South Texas Project Electric Generating Station P.O. Box 289 Wadsworth, Texas 77483

May 18, 2010
NOC-AE-10002532
File No.: G25
10 CFR 50.90

South Texas Project
Units 1 and 2
Docket Nos. STN 50-498, STN 50-499
License Amendment Request for
Reactor Coolant System Pressure Transmitter Replacement

Subject: License Amendment Request for Reactor Coolant System Pressure Transmitter Replacement

SCHEMATIC OF TYPICAL RESIDUAL HEAT REMOVAL SYSTEM INLET LINE ISOLATION VALVE ARRANGEMENT

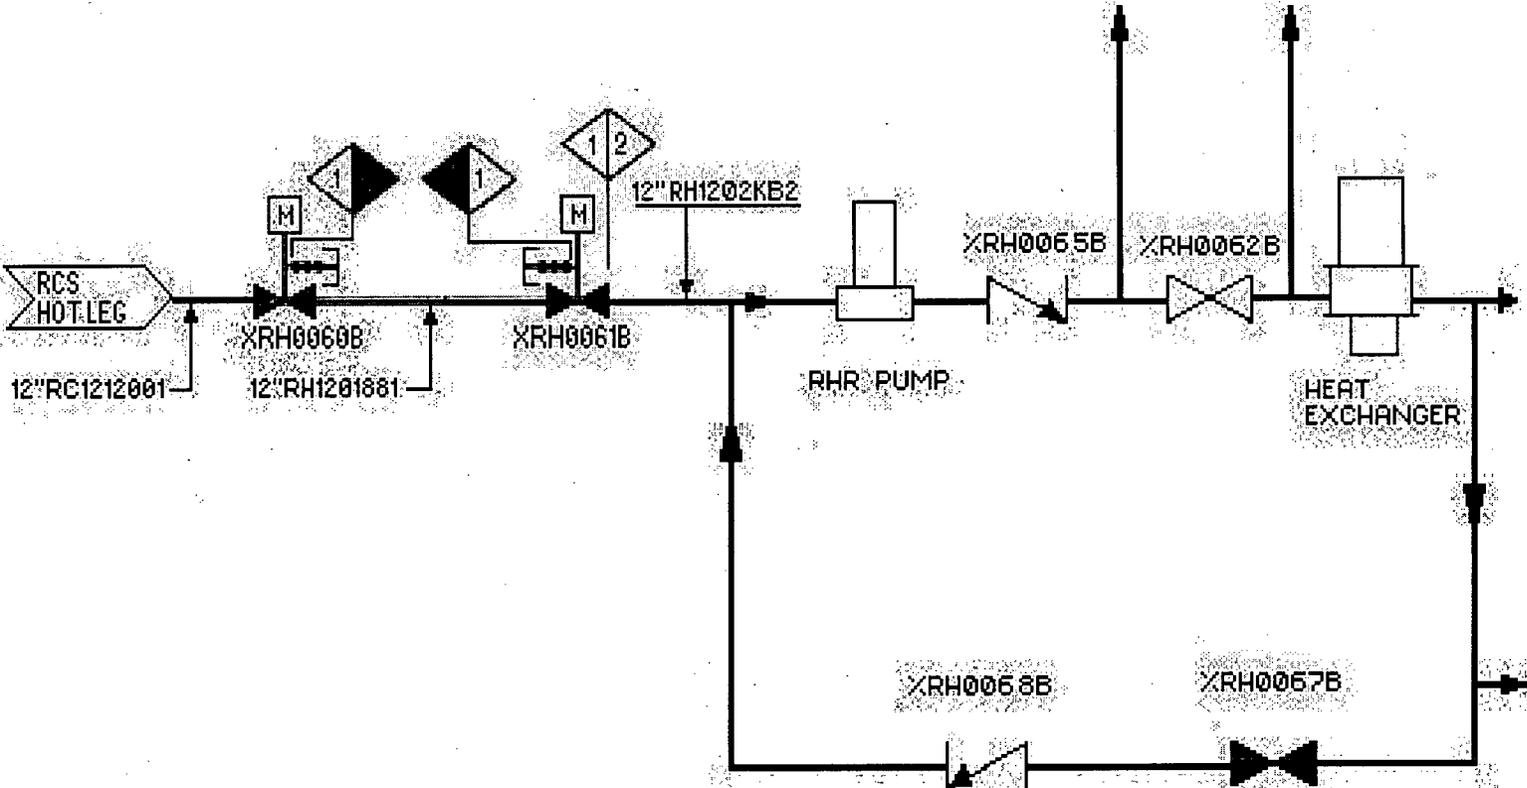
There are three isolation interlock pressure transmitters, and three RHR trains with two isolation valves on each RHR inlet line. Each pressure transmitter controls two RHR inlet line isolation valves (one closer to the RCS, and one closer to the RHR pump), but on different trains. If a pressure transmitter is not functional, a separate transmitter keeps the companion valve closed when RCS pressure exceeds RHR pressure.

A pressure transmitter signal provides a permissive that allows the associated valve to be opened. Without the required signal, the "open" permissive ensures that the valve does not open when the combination of the RCS pressure and the RHR pump discharge pressure exceeds the RHR system design pressure. The two valves in each RHR train receive "open" signals from different pressure transmitters through the Engineered Safety Features (ESF) actuation train.

Using two independently powered motor-operated valves (MOVs) in each of the three inlet lines, along with independent pressure interlock signals for the "prevent-open" function, assures that the design meets applicable single failure criteria. In each RHR subsystem, the interlock signal provided to the isolation valve closest to the RCS is independent and from the interlock signal provided to the isolation valve closest to the RHR. More than one single failure must be postulated to defeat the function preventing exposure of the RHR system to RCS normal operating pressure. The protective interlock design, in combination with plant operating procedures, provides a means of accomplishing the protective function.

The two valves in each RHR system inlet line are powered from different Class IE power sources. Diversity in preventing exposure of the RHR system to the higher RCS pressure is provided by locking out power to the isolation valves in each train at the motor control center when the RHR system is not in service to prevent spurious opening of a valve during plant operation. This power lockout must be disabled before the valves can be opened.
